RC3: [Comment on hess-2024-7](#), Anonymous Referee #3, 22 May 2024

Review for “System dynamics perspective: lack of long-term endogenous feedback accounts for failure of bucket models to replicate slow hydrological behaviors”

The study uses a system dynamics approach aiming to reveal endogenous factors that account for the long-term slow dynamics of a catchment hydrological system. The paper addresses relevant problem within the scope of HESS, the topic is interesting and widely discussed. However, my recommendation is major revision due to several significant issues in the methodology that seem inadequate for addressing the posed research questions. Further justification is also necessary for the conclusions made. Below are my main concerns.

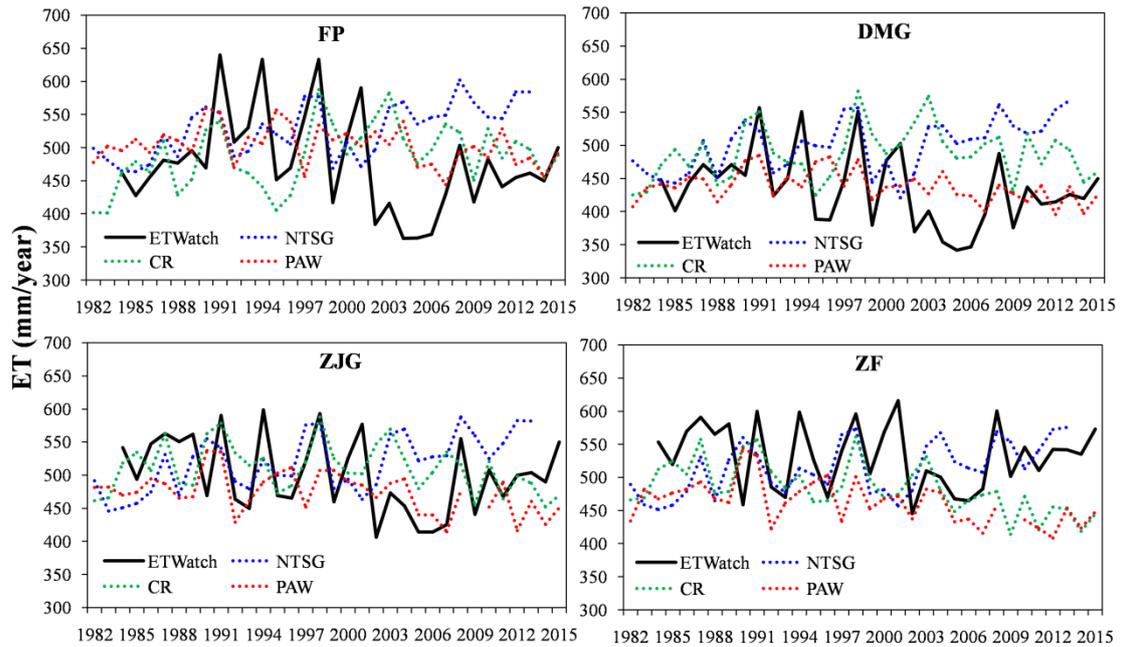
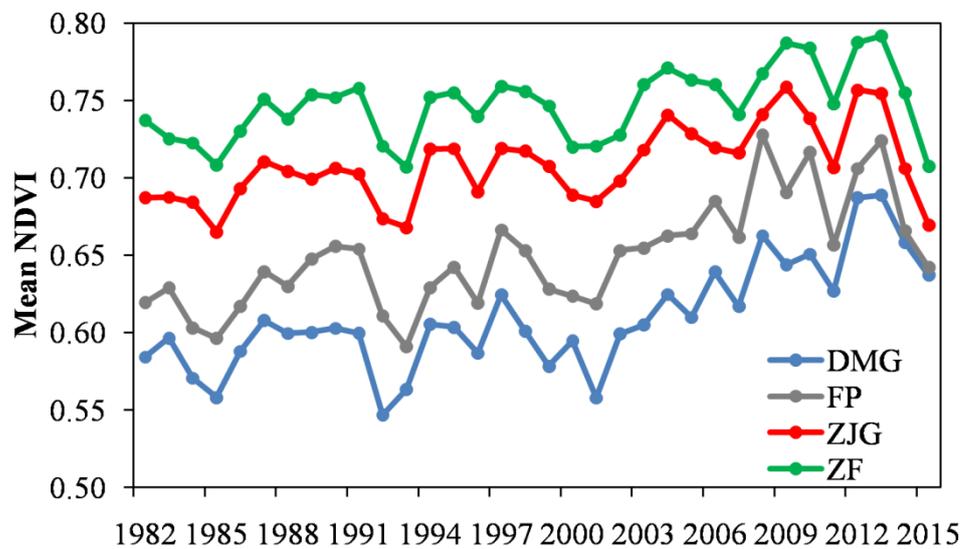
The products of actual evapotranspiration contain much uncertainties. The authors should be very careful with the products and validation of the accuracy in the region is recommended.

Reply: Thank you for the comment. Due to the absence of ET observations during study period, we resorted to three alternative ET products - NTSG (Numerical Terra-dynamic Simulation Group), CR (Complementary-Relationship-based modeling), and PEW (Proportionality hypothesis-based surface Energy-Water balance model) - for cross-validation with ETWatch (as depicted in the figure below). These products employ distinct algorithms, namely Penman-Monteith for NTSG (Zhang et al., 2009a,b), Complementary-relationship for CR (Ma et al., 2019a,b), and Priestley-Taylor for PEW (Fu et al., 2022a,b). Despite their algorithmic difference, they exhibit common characteristics in long-term data.

Firstly, all the products successfully capture the annual ET fluctuations. Secondly, in terms of long-term trends, all products indicate a decline in ET in the end of 1990s and the beginning of 2000s. While the ET of NTSG and ETWatch shows an upward trend thereafter, however, the ET of CR and PEW continues to decrease in the study period. Thirdly, the magnitude of ET fluctuations is comparable among all the four products, being more pronounced during the wet phase and less so during the dry phase.

Given these observations, we conclude that the ETWatch product demonstrates reliable values and the most distinguishable fluctuations among the four ET products, thus standing out as a reliable choice for ET estimation.

The above paragraph has been added in Method section.

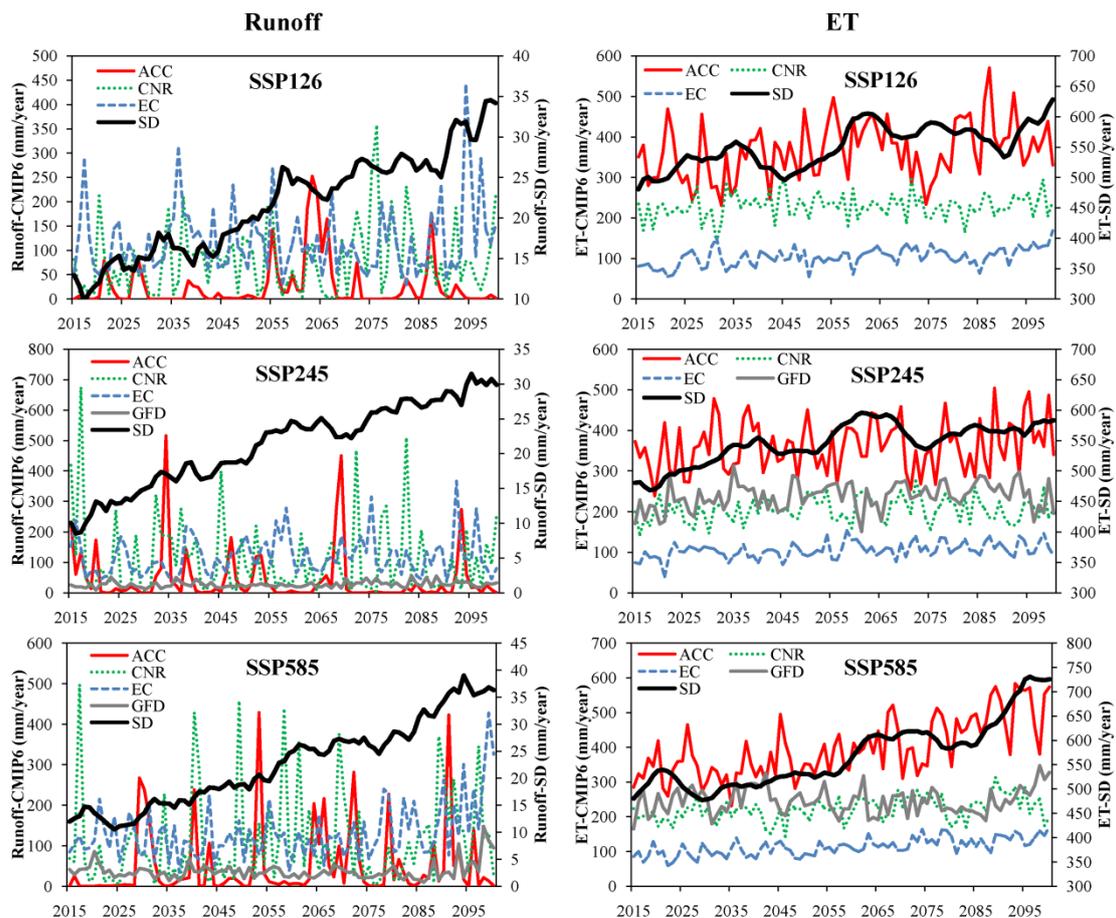
Future dynamics of hydrological systems under three climatic scenarios are shown in Fig 7. But could not catch what the key points the author wanted to address.

Reply: Thank you for the comment. The figure has been updated to a new version that contrasts our results with CMIP6 results (as illustrated below). It encompasses monthly total runoff ("mrrro" in CMIP6) and evapotranspiration ("evspsblsoil" and "evspsblveg" in CMIP6), stemming from three scenarios (SSP126, SSP245, and SSP585) within four Global Climate Models (ACCESS-CM2, CNRM-ESM2, EC-Earth3, and GFDL-CM4). These data were retrieved from the CMIP6 (the phase 6 of the Coupled Model Intercomparison Project) website (<https://esgf-node.llnl.gov/search/cmip6/>), covering the time span from 2015 to 2100. Notably, the GFDL-CM4 model lacks the SSP126 experiment, and the ACCESS-CM2 model lacks the "evspsblveg" variable.

The spatial resolution varies, with 250 km for ACCESS-CM2 and CNRM-ESM2 models, and 100 km for EC-Earth2 and GFDL-CM4 models. The values pertaining to the study area were extracted from specific grid cells. For ACCESS-CM2 (CNRM-ESM2), the grid value at the 62nd (83rd) row and 104th (93rd) column, corresponding to longitudes of 115.3125° (115.3125°) and latitudes of 39.375° (39.9218°), were used. Similarly, for EC-Earth3 (GFDL-CM4), the grid values at the 164th (92nd) and 165th (93rd) rows, and the 185th (130th) column, corresponding to longitudes of 114.6094° (114.375°) and 115.3125° (115.625°), and latitudes of 39.649° (39.5°), were utilized.

The unit of $\text{kg m}^{-2} \text{s}^{-1}$ was converted to mm month^{-1} by multiplying it with 86400 seconds and 30 day. Subsequently, annual values were calculated by summing the monthly values. The average precipitation from different SSP scenarios was then employed to drive system dynamics (SD) model, generating runoff and evapotranspiration estimates.

In term of evapotranspiration (ET), SD model aptly captures its primary behavioral patterns: a decline in the 2040s and 2070s, followed by an increase in the 2060s and 2090s. Notably, the R-squared value between SD model and GCMs for ET is relatively higher for the SSP585 experiment, specifically 0.48 for ACCESS-CM2, 0.15 for CNRM-ESM2, 0.41 for EC-Earth2, and 0.04 for GFDL-CM4. However, for other two experiments, the R-squared values are relatively poor.

Regarding runoff, the SD simulations indicate an increasing trend, whereas the GCMs do not exhibit any discernible trend. The R-squared values between SD and GCMs for runoff are poor across all experiments. These findings further emphasize that process-based models, while adept at capturing short-term fluctuations, may be inadequate in simulating long-term hydrological behaviors.

MK trend analysis for precipitation

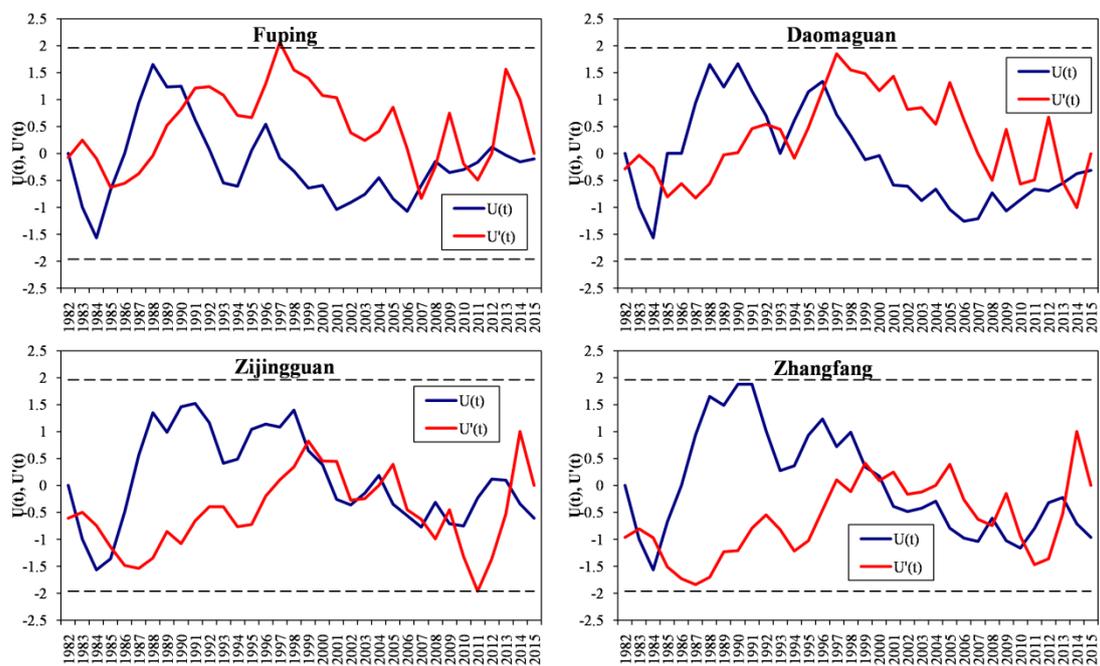
Lines 210-214. The brief description of hydrological characteristics of the wet and dry phase is suggested. Why the wet-dry phase be determined by wavelet coefficient instead of annual precipitation or aridity index?

Reply: Thank you for the comment. To distinguish between wet and dry phase, a comprehensive analysis was undertaken, encompassing wavelet analysis, trend analysis of precipitation and runoff (as figures below), and a literature review about

climate and runoff patterns. Results revealed that precipitation did not exhibit a significant trend, whereas runoff showed a significant decreasing trend during the study period, with a tipping point around 2000, aligning with previous studies. The literature review highlighted that the PDO index, which is closely associated with summer rainfall in East China, underwent a shift from positive to negative phase at the end of 1990s. Furthermore, wavelet analysis indicated a reduction in the magnitude of fluctuations in wavelet coefficients for all 4 variables after 2000. Based on this collective evidence, it was determined that the hydrological system has transitioned from wet phase to dry phase in 2000.

This description will be added in Method section and figures will be added in supplementary document.
